HUDSON PLACE SUBDIVISION, RESUBDIVISION OF LOT 706, CAROL PLANTATION, 6TH UNIT

APPLICATION NUMBER 4 DATE August 18, 2016
 APPLICANT Hudson Place Subdivision, Resubdivision of Lot 706 Carol Plantation 6th Unit
 REQUEST Subdivision

DETAIL SITE PLAN

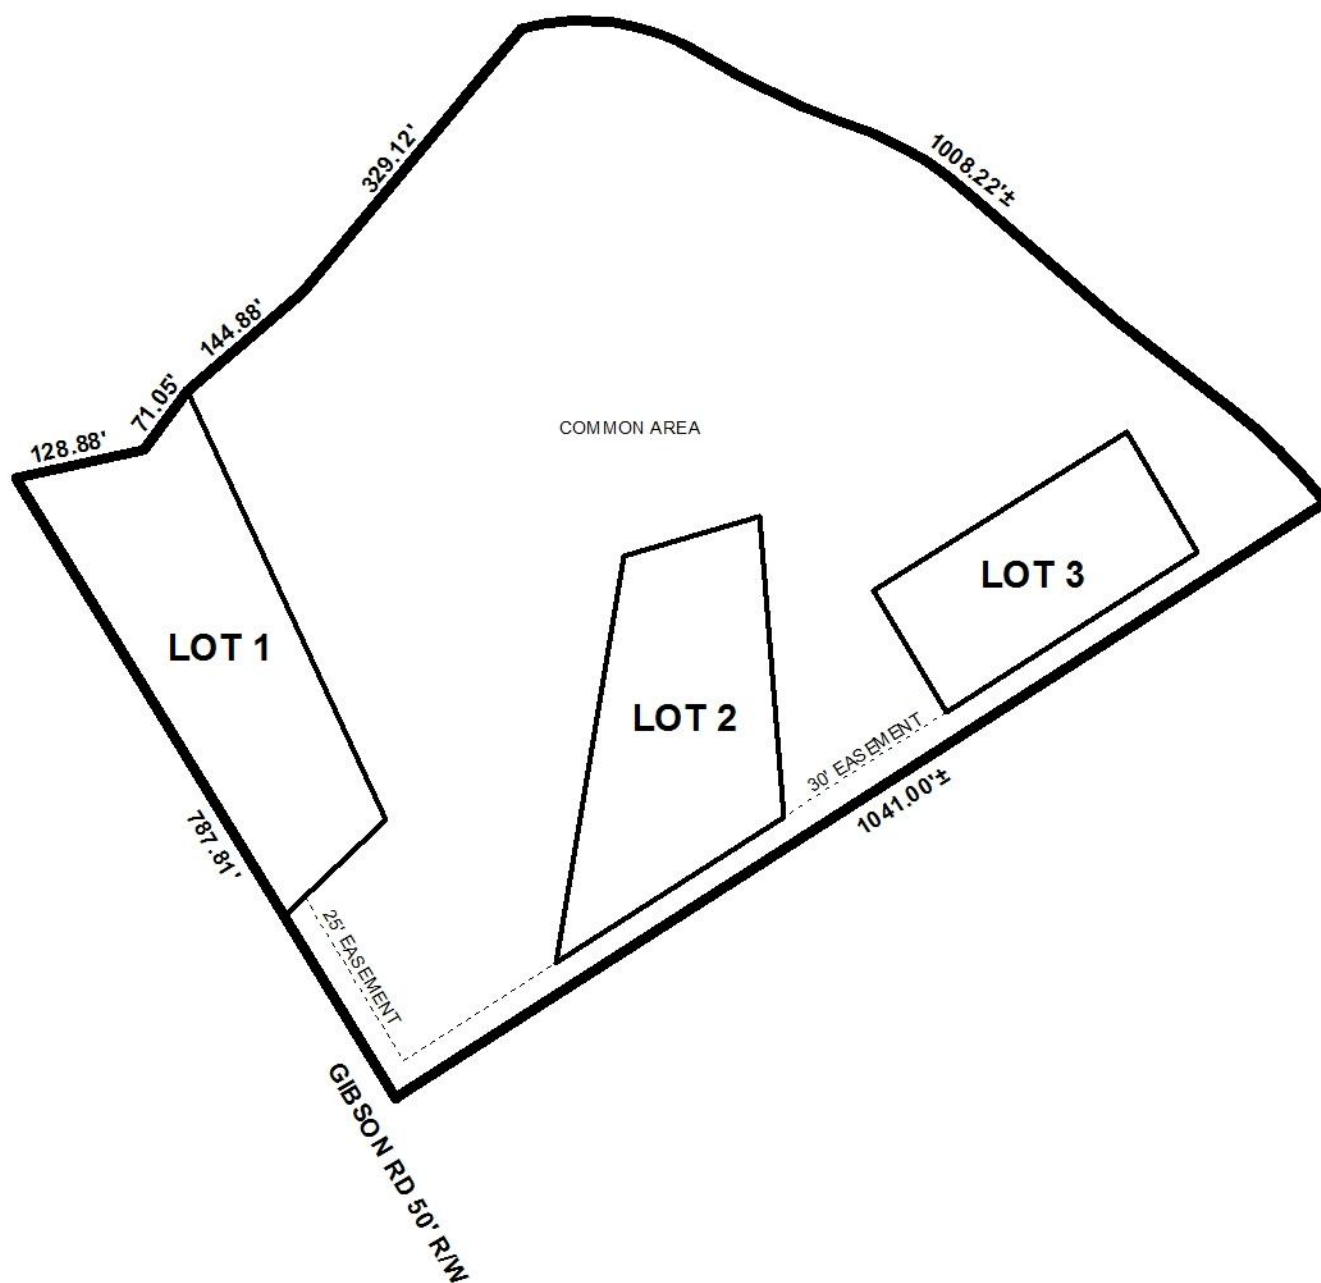
The plat illustrates the proposed 3-lot, 17.5± acre subdivision located at the North terminus of Gibson Road, within the Planning Jurisdiction. The applicant states that the subdivision is served by public water and individual septic tank services. This contradicts the MAWSS statement concerning water service availability; however, it would have no impact on the lot sizes as proposed.

The site has 25' of frontage on the North terminus of Gibson Road which is a public street with a 50' right-of-way. Access to Lot 1 would be via a 25' recorded easement extending Northward from Gibson Road, and access to Lots 2 and 3 would be via a proposed 30' easement extending Eastwardly from the 25' easement and running along the South side of the site. Therefore, a waiver of Section V.D.4. of the Subdivision Regulations (*Lot to Abut on a Street*) will be required in order to approve the lots as submitted, and such a waiver may be advisable due to the innovative aspect of creating lots within an overall Common Area. No improvements are proposed for the easements which would basically be private streets. Therefore, no additional

subdivision of the site should be allowed until the easements are improved to the private street standards contained within Section VIII.E. of the Subdivision Regulations and additional frontage to provide 50' at the North terminus of Gibson Road is obtained. Both easements and all three lots would have access to the Common Area.

Section V.D.9. of the Subdivision Regulations requires the provision of a 25' minimum building setback from the "front property line", which in this case, staff has determined to be where the recorded and proposed easements abut the proposed lots. Therefore, the plat should be revised to indicate a 25' minimum building setback block-out for Lot 1 at the North terminus of the 25' easement, and as measured from the 30' easement along the South lines of Lots 2 and 3.

The proposed lots meet the minimum size requirements of the Subdivision Regulations, and as on the preliminary plat, all lots and the Common Area should be labeled with their sizes in both square feet and acres, or a table should be furnished on the Final Plat providing the same information. As the site will contain easements, a note should be required on the Final Plat stating that no structures may be placed or constructed within any easement.

As the subdivision would have a recorded Common Area, a note should be required on the Final Plat stating that the maintenance of the Common Area is the responsibility of the property owners.

- 1) no additional subdivision of the site is allowed until all easements are improved to the private street standards contained within Section VIII.E. of the Subdivision Regulations and additional frontage to provide 50' at the North terminus of Gibson Road is obtained;
- 2) revision of the plat to indicate a 25' minimum building setback block-out for Lot 1 at the North terminus of the 25' easement;
- 3) revision of the plat to indicate a 25' minimum building setback for Lots 2 and 3 as measured from the 30' easement along the South line of those lots;
- 4) retention of the labeling of all lots and the Common Area with their sizes in both square feet and acres, or the furnishing of a table on the Final Plat providing the same information;

- 5) placement of a note on the Final Plat stating that no structures may be placed or constructed within any easement;
- 6) placement of a note on the Final Plat stating that the maintenance of the Common Area is the responsibility of the property owners;
